6/24/14	Added New Sheet.
DATE	REVISION
STATE OF HAWAII DEPARTMENT OF TRANSPORTATION HIGHWAYS DIVISION	
WATER POLLUTION & EROSION CONTROL NOTES	
HALEAKALA HIGHWAY INTERSECTION IMPROVEMENTS AT KULA HIGHWAY Project No. 37C-01-14	
Date: June, 2014	
SHEET No. 1 OF 3 SHEETS

6/24/14	Added Notes.
DATE	REVISION
STATE OF HAWAII DEPARTMENT OF TRANSPORTATION HIGHWAYS DIVISION	
TYPICAL SECTIONS & DETAILS	
HALEAKALA HIGHWAY INTERSECTION	
IMPROVEMENTS AT KULA HIGHWAY	
Project No. 37C-01-14	
Scale: As Shown	Date: April, 2014
SHEET No. 1 OF 3 SHEETS

DEMOLITION PLAN

**HALEAKALA HIGHWAY INTERSECTION
IMPROVEMENTS AT KULA HIGHWAY**

TYPICAL ROAD SECTION - HALEAKALA HIGHWAY
 Scale: 1/4" = 1'-0"

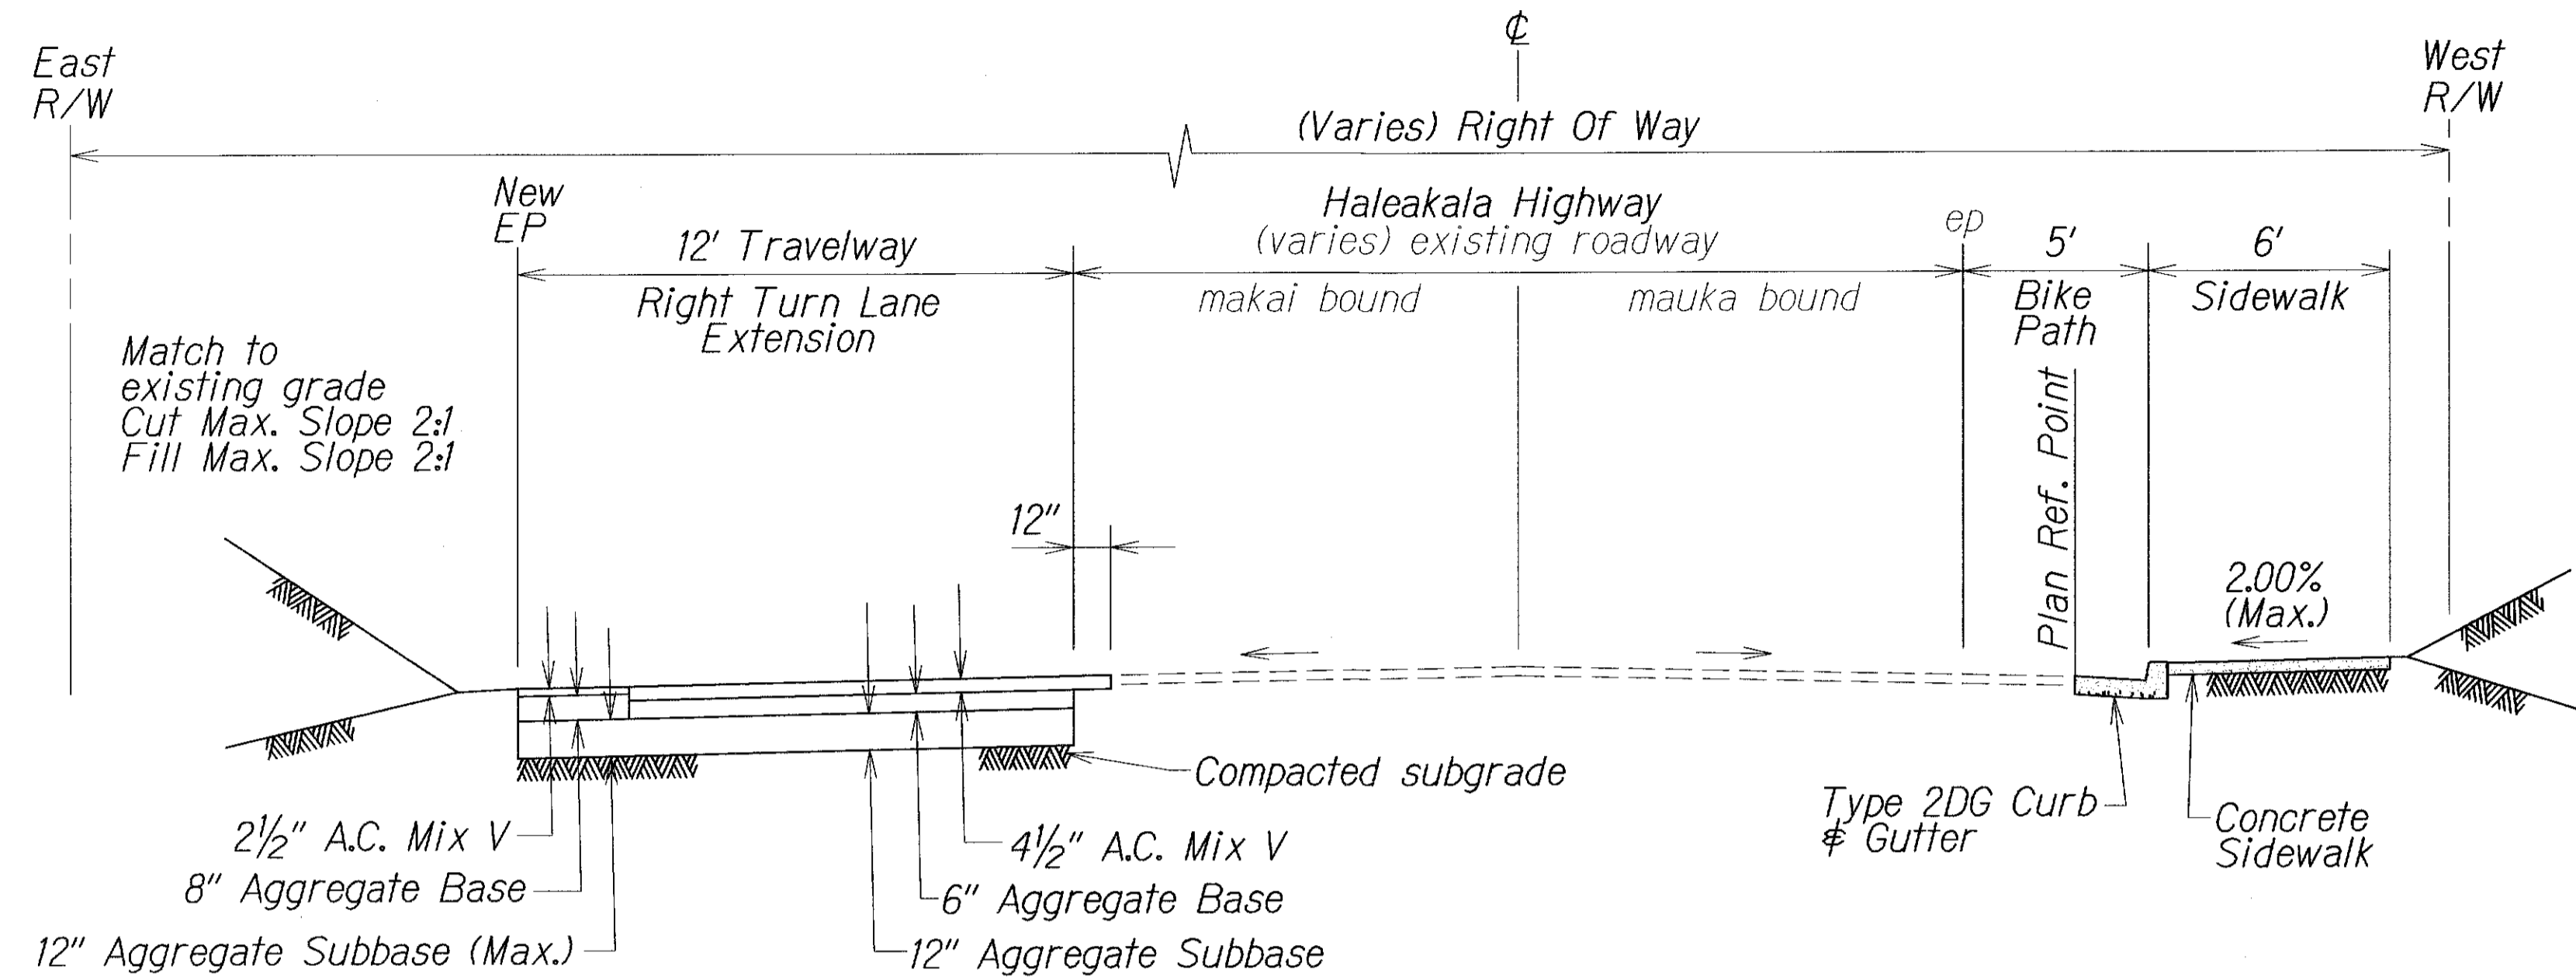
6/24/14	Added Notes.
DATE	REVISION

- NOTES:
1. All Aggregate Base and Subbase shall be Incidental to Item No. 401.1000.
 2. All Bed Course and Subbase under Sidewalk shall be Incidental to Item No. 634.1000.
 3. All Bed Course and Subbase under Curb and Gutter shall be Incidental to Item No. 638.1000.

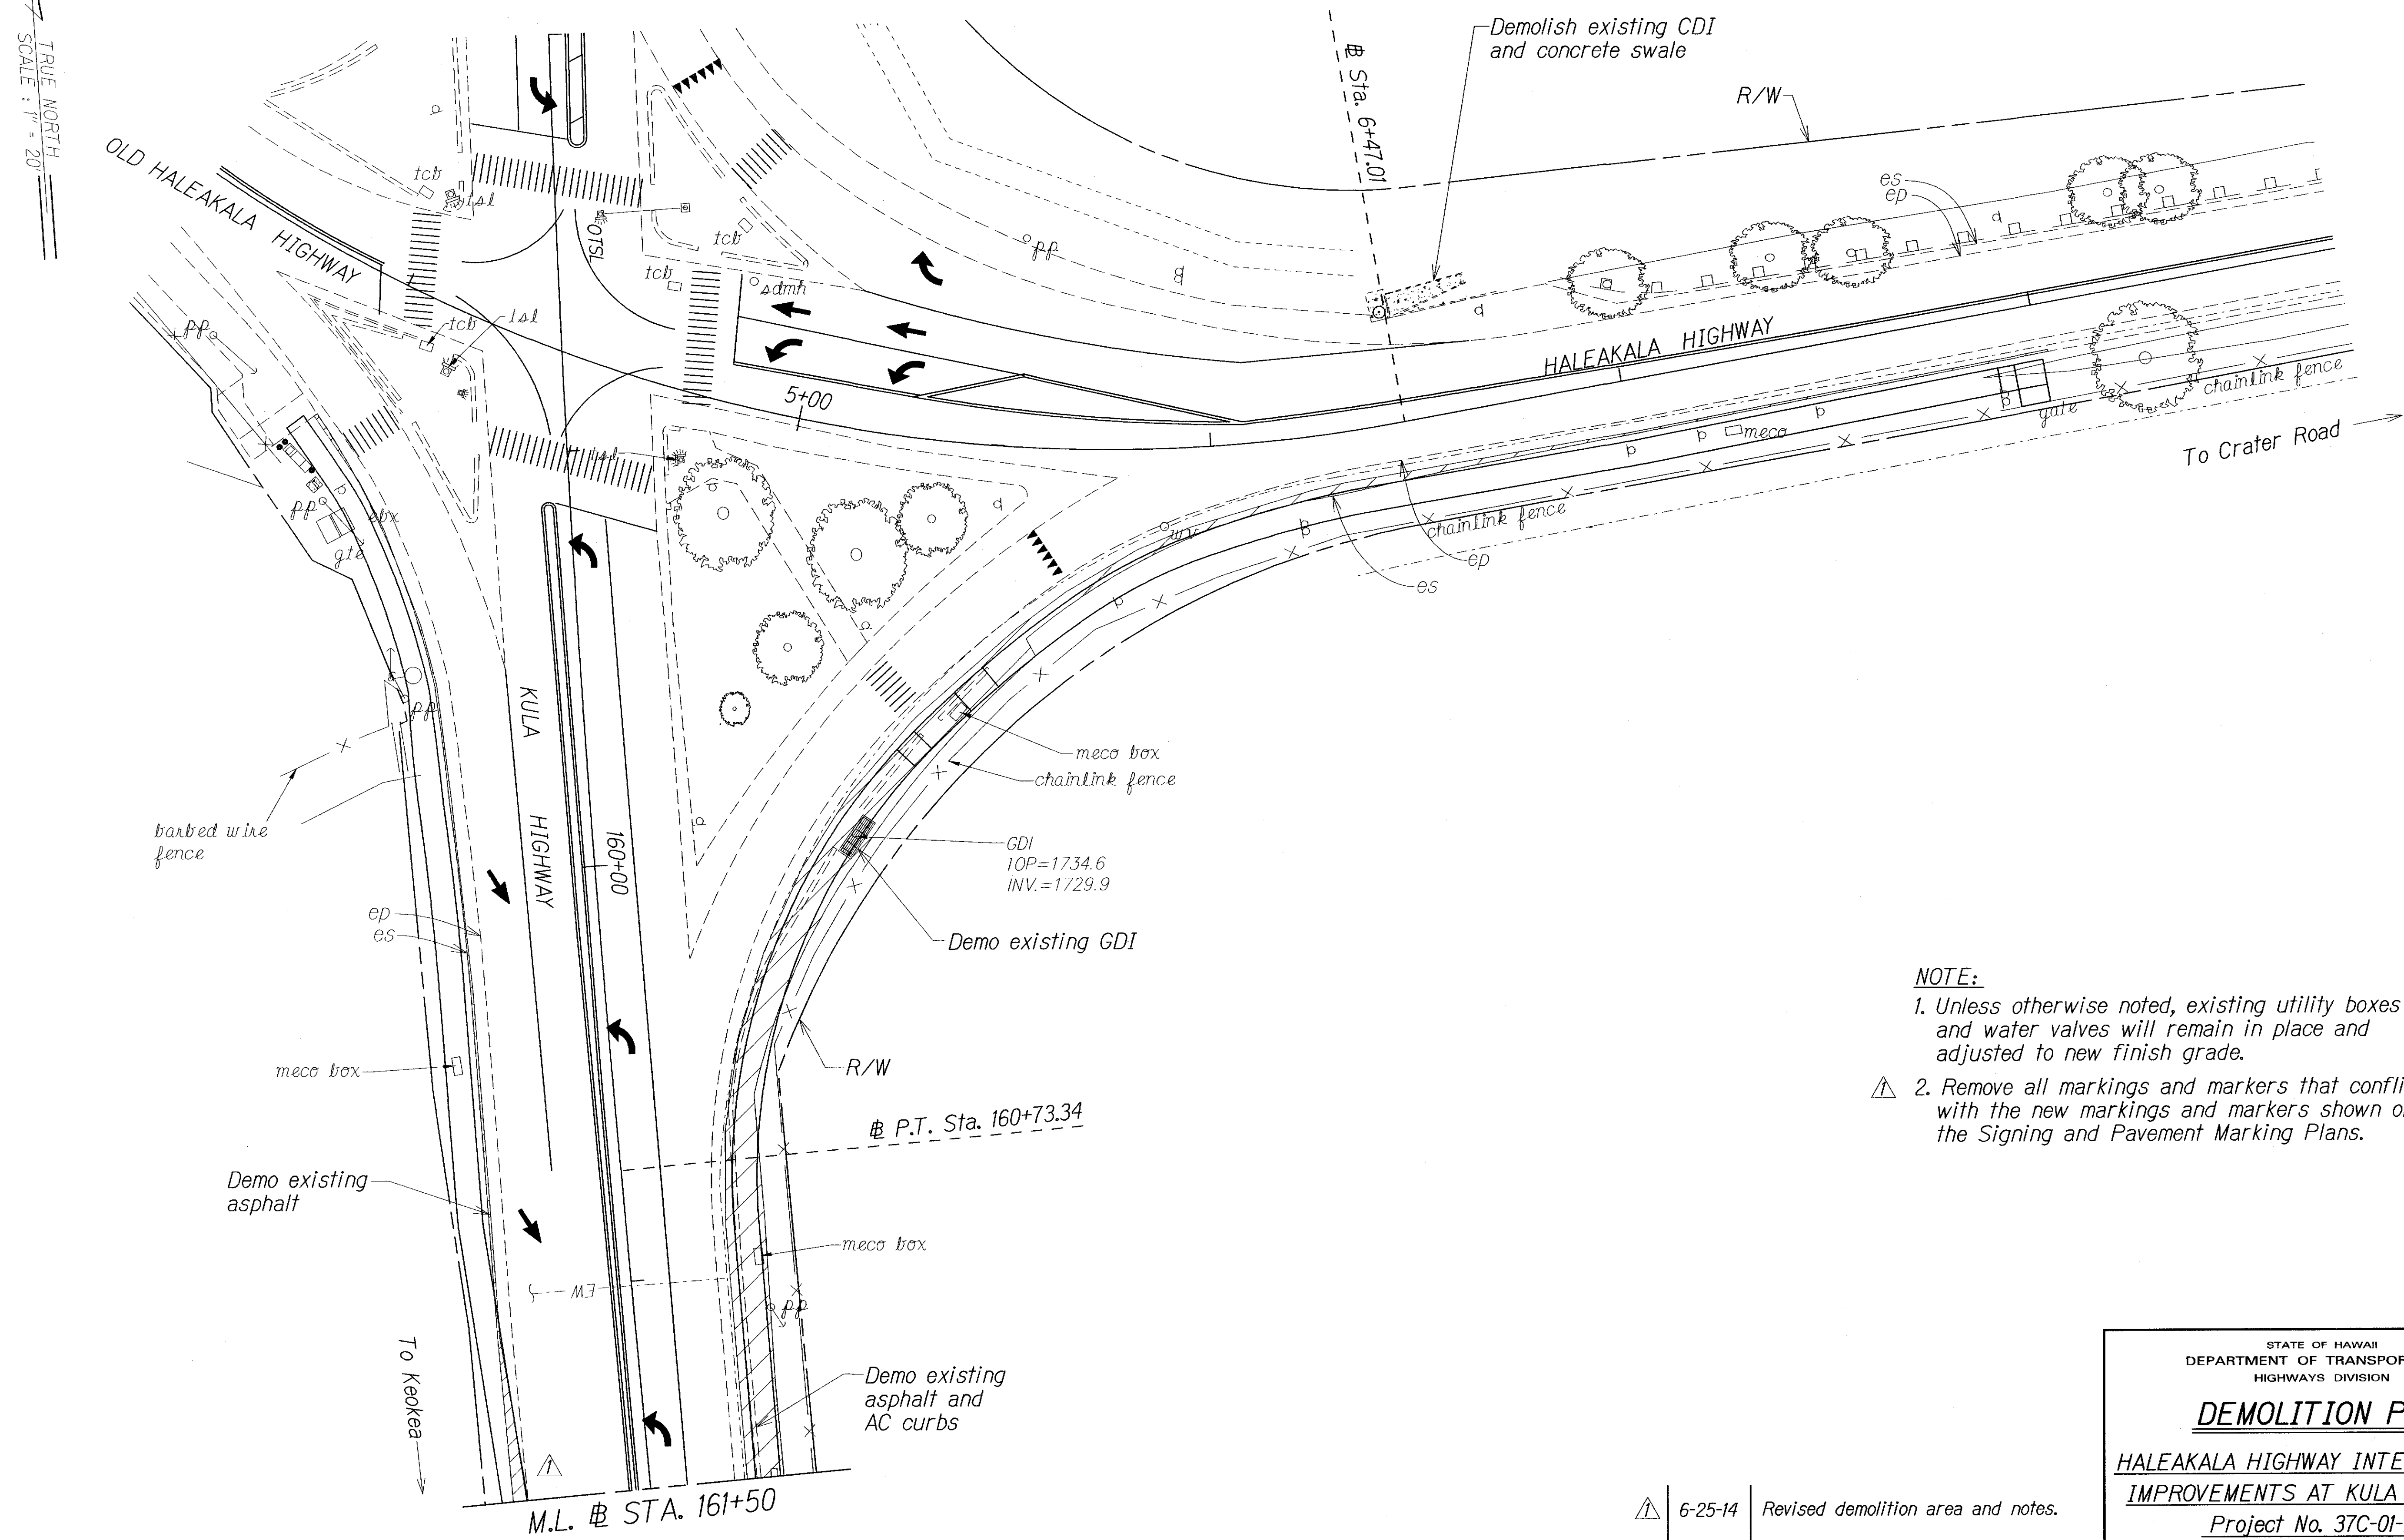
6-25-14	Revised demolition area and notes.
DATE	REVISION

- NOTE:**
1. Unless otherwise noted, existing utility boxes and water valves will remain in place and adjusted to new finish grade.
 2. Remove all markings and markers that conflict with the new markings and markers shown on the Signing and Pavement Marking Plans.

DEMOLITION PLAN

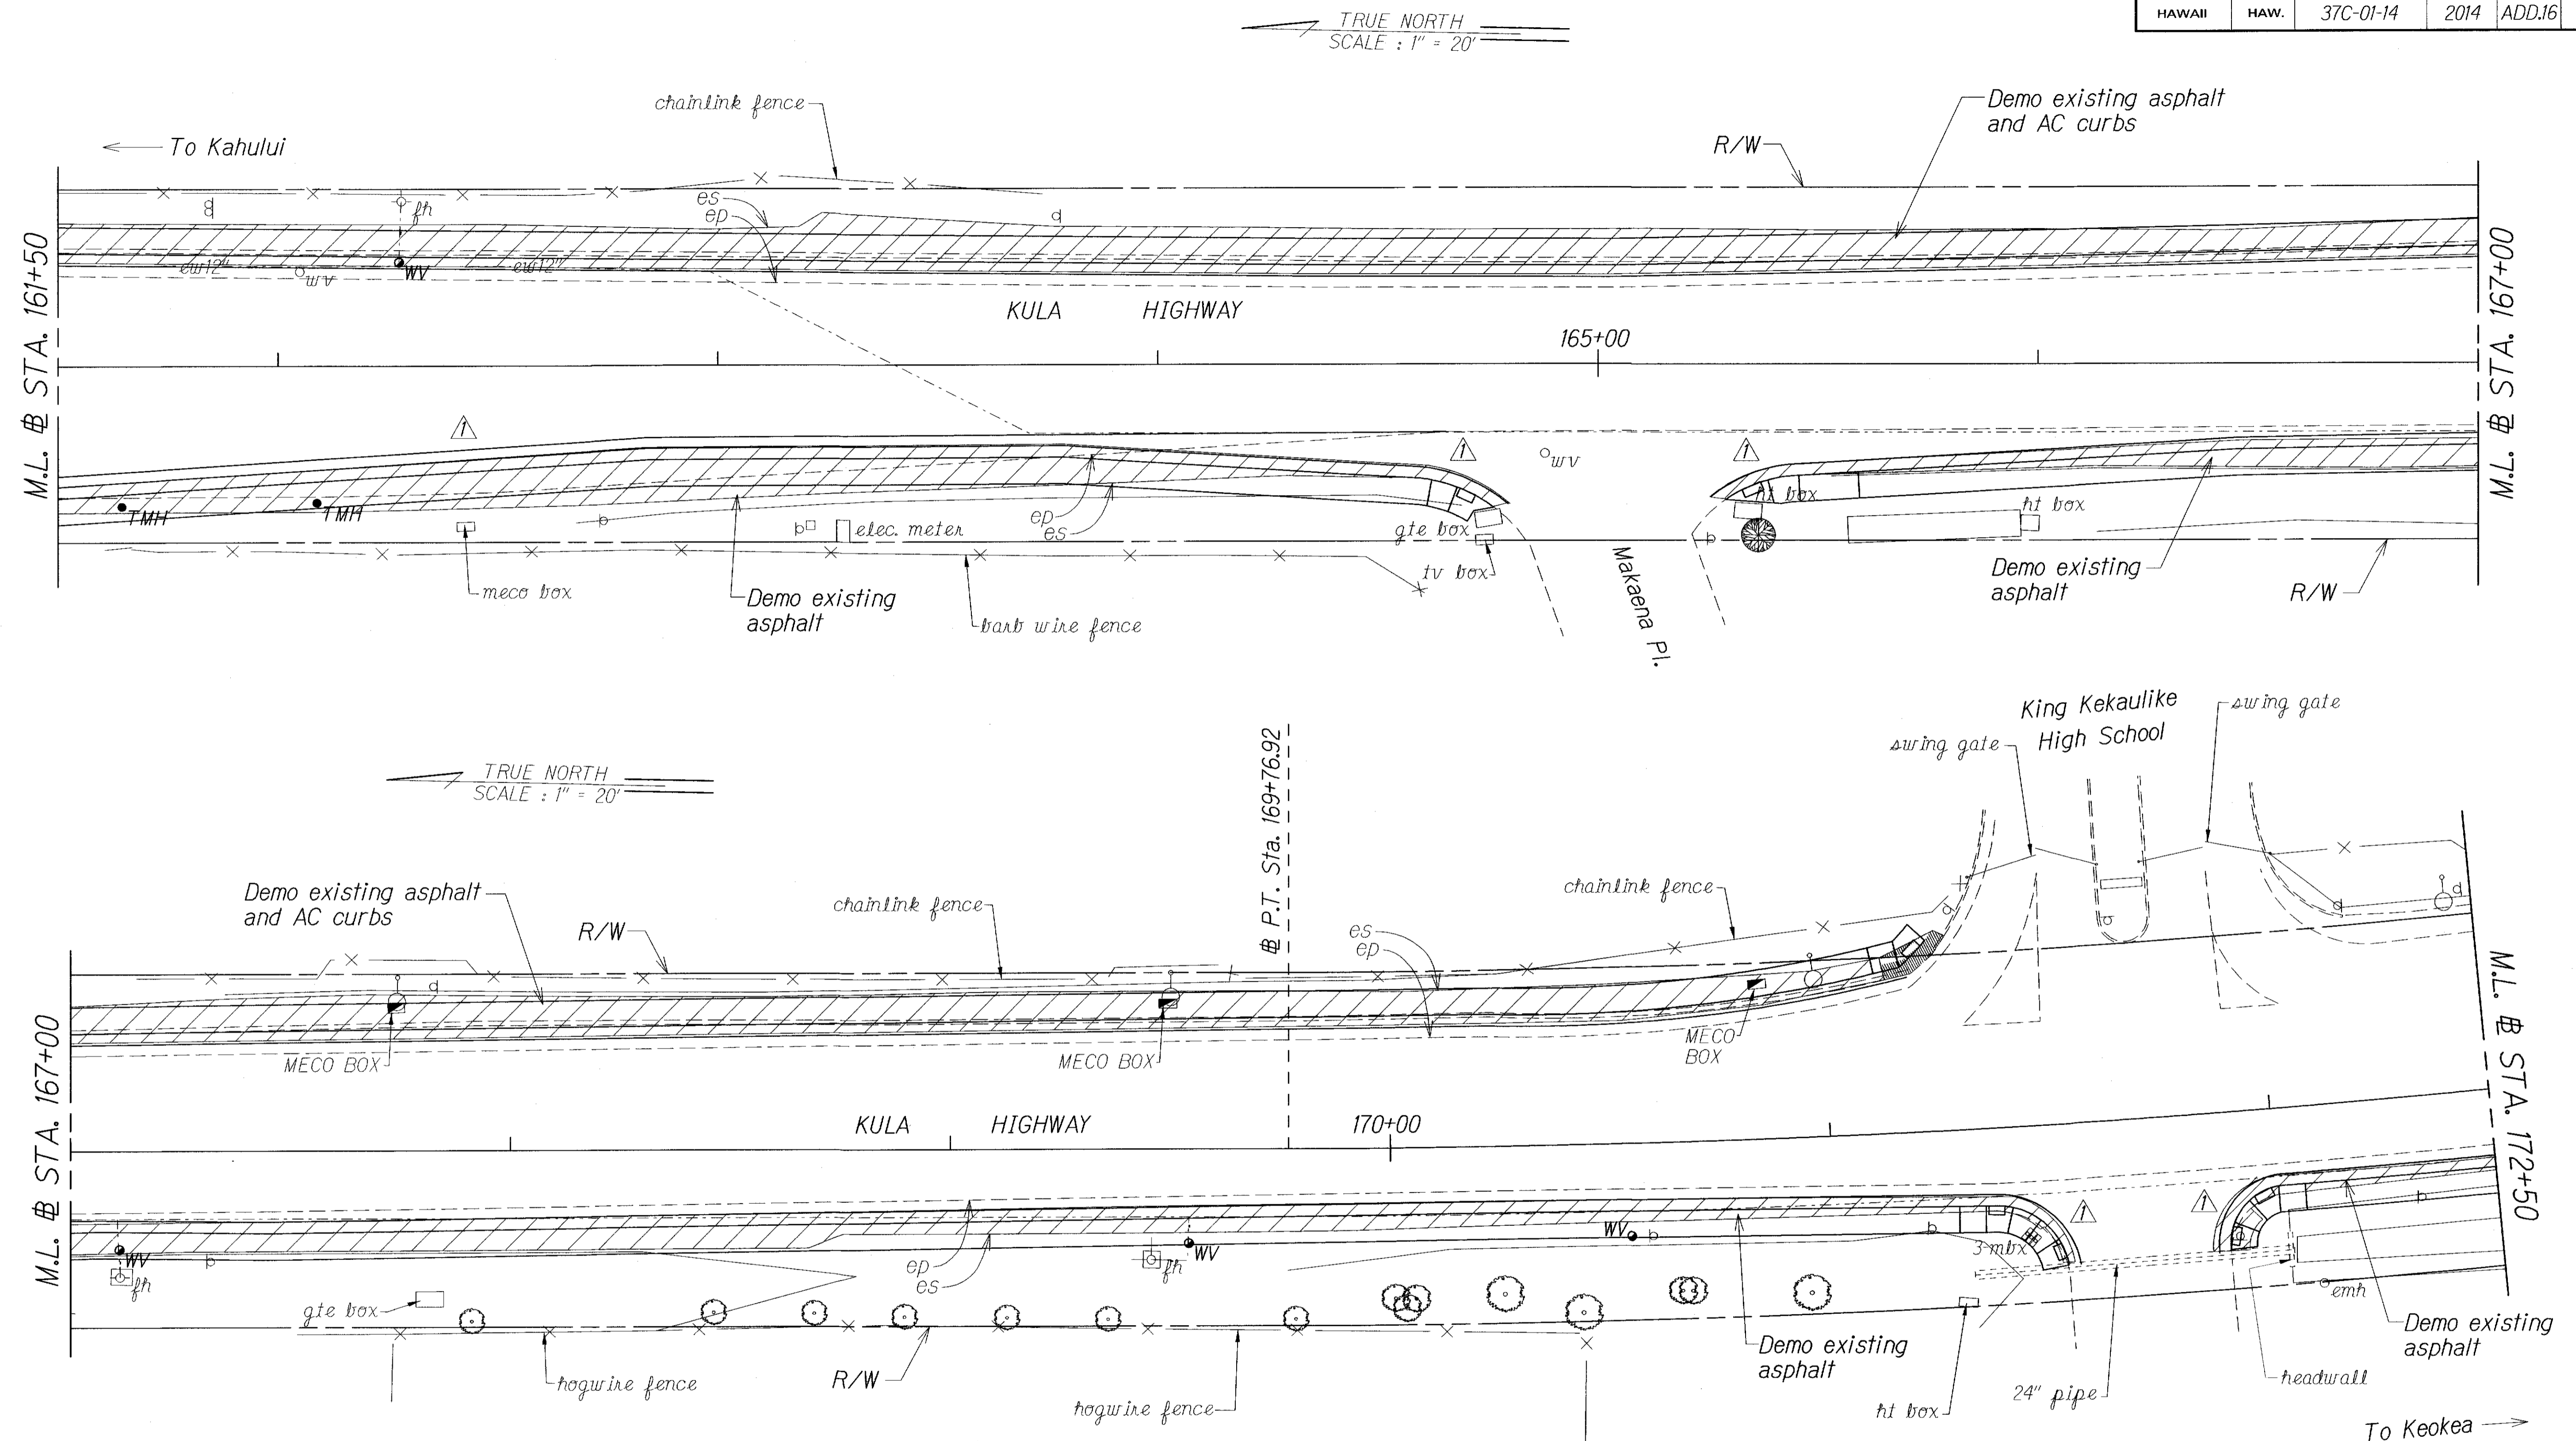
6-25-14	Revised demoltion area.
DATE	REVISION
